PROPOSED REAR EXTENSION AND RELATED WORKS: 3 Lamorna Gardens, Ferring, BN12 5QD

DRAWING: PROPOSED ELEVATIONS AS PASSED ON APP FG/217/18/HH **SCALE:** 1:100 @ A3 **DATE:** 04/08/2019 **DRAWING No:** DS/LAMORNA/05rev3

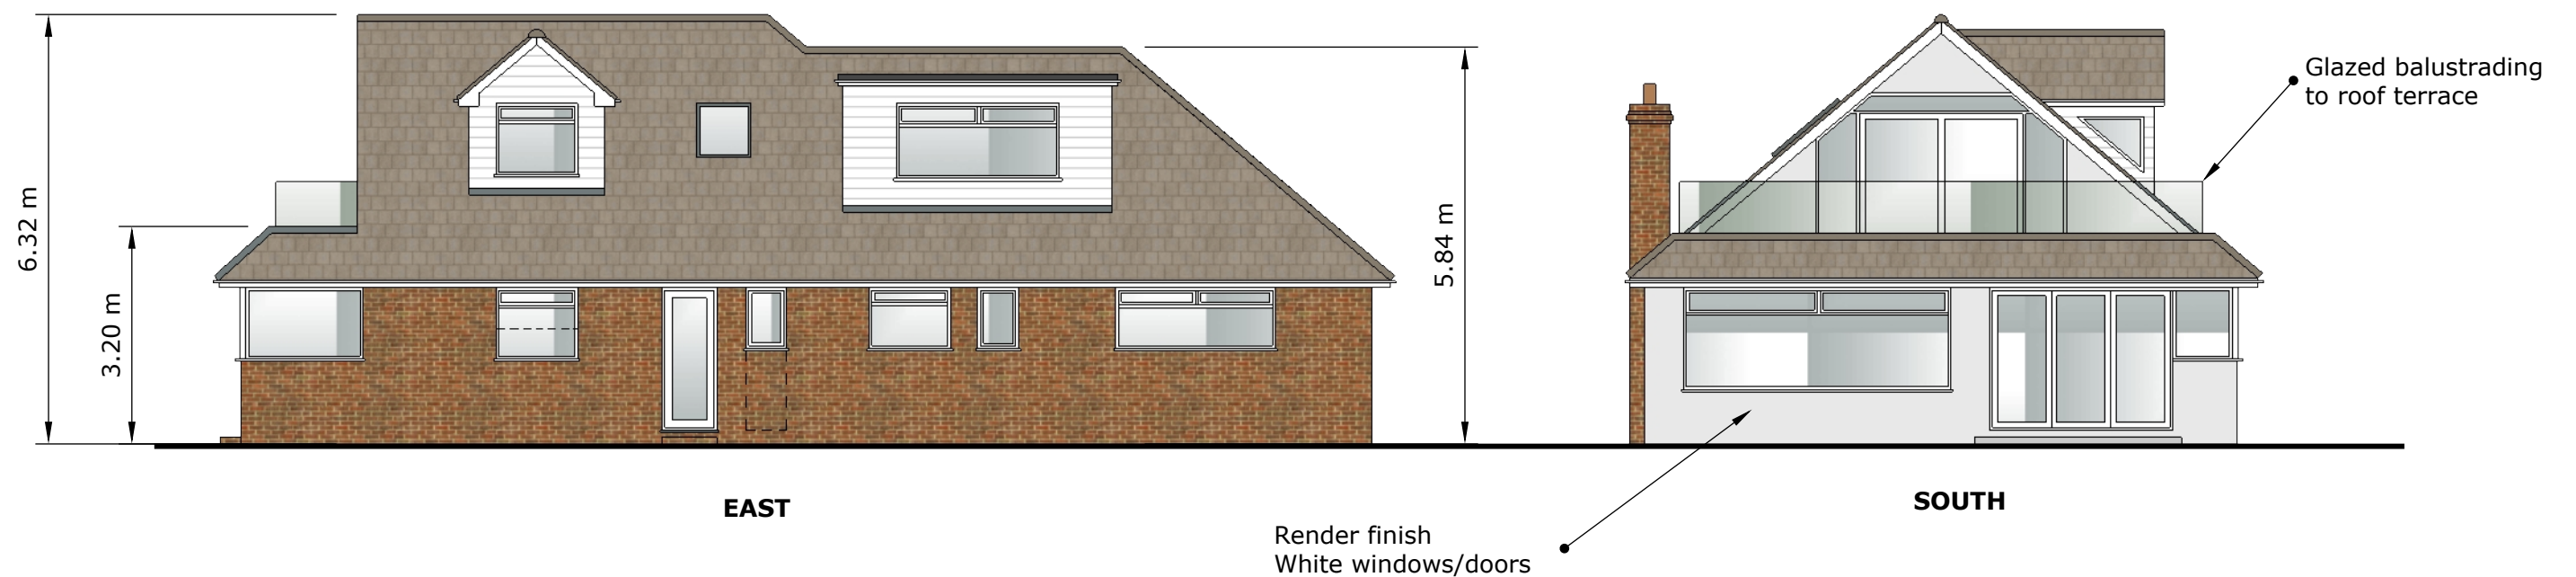
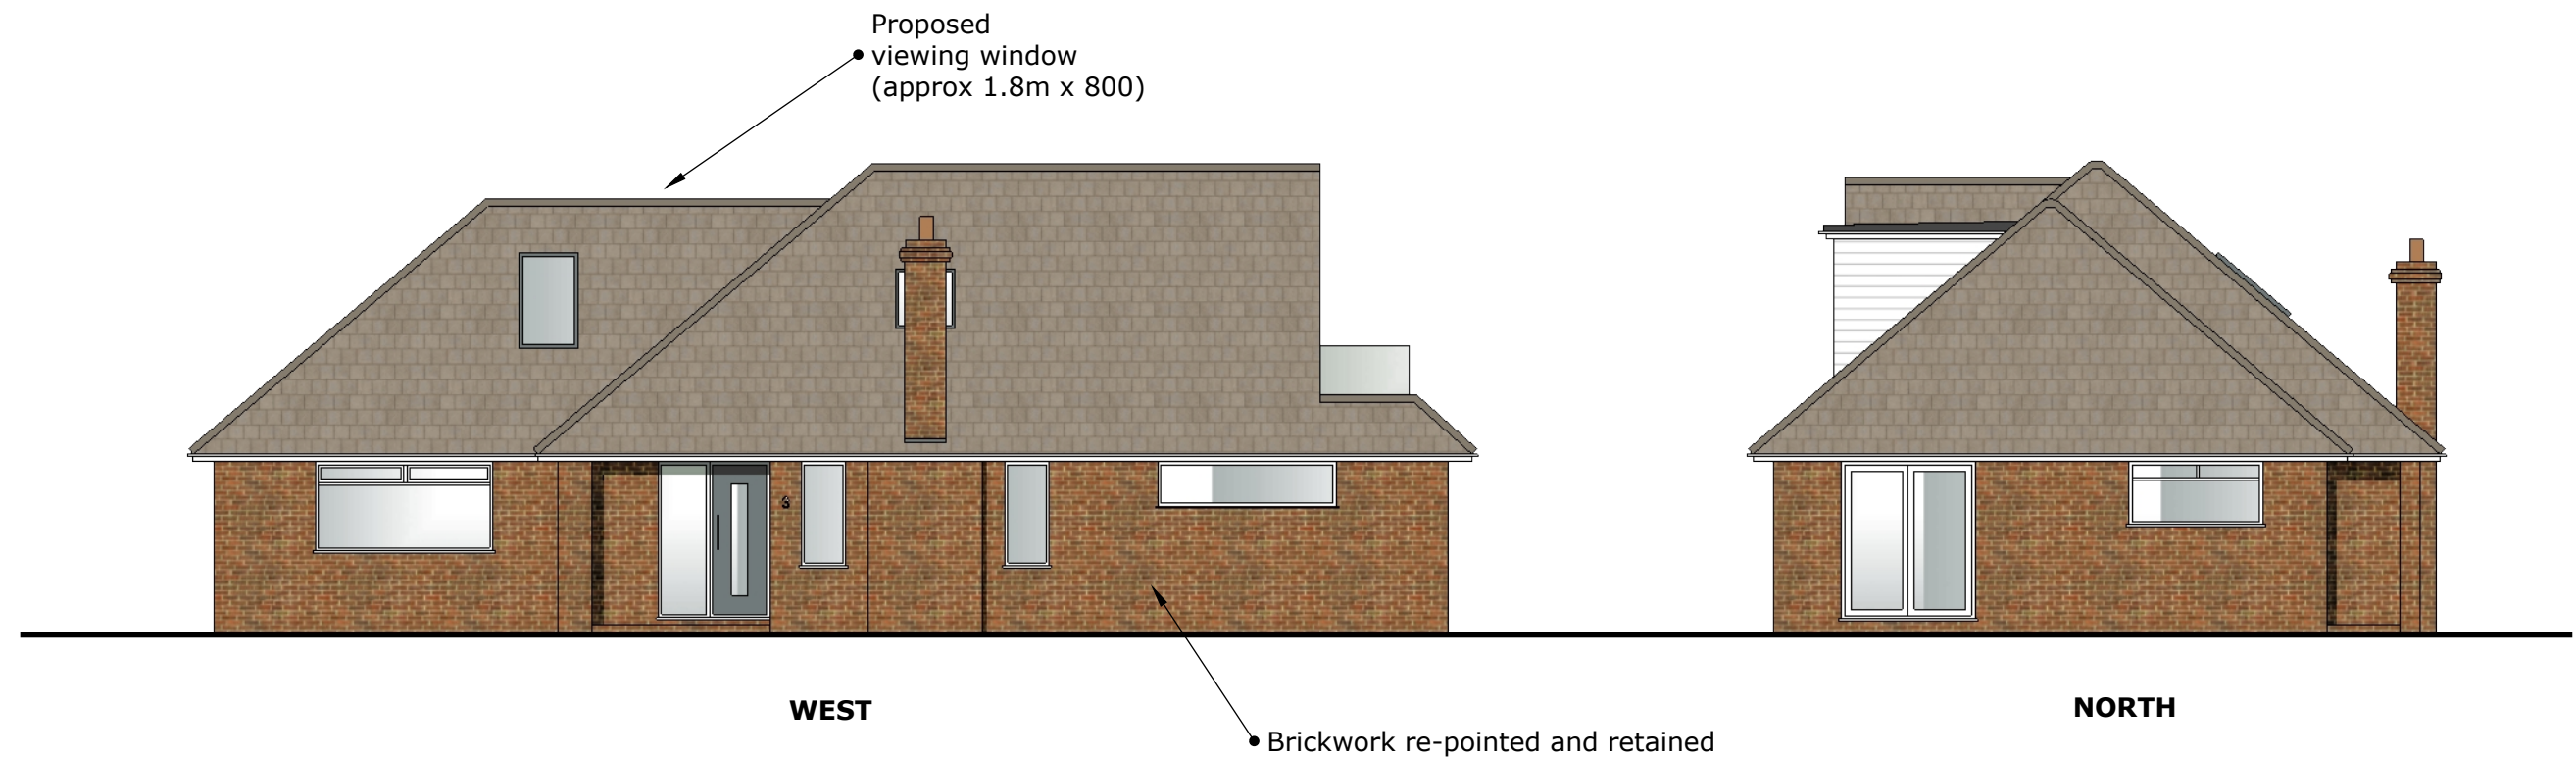
Revised to show second dormer on North elevation
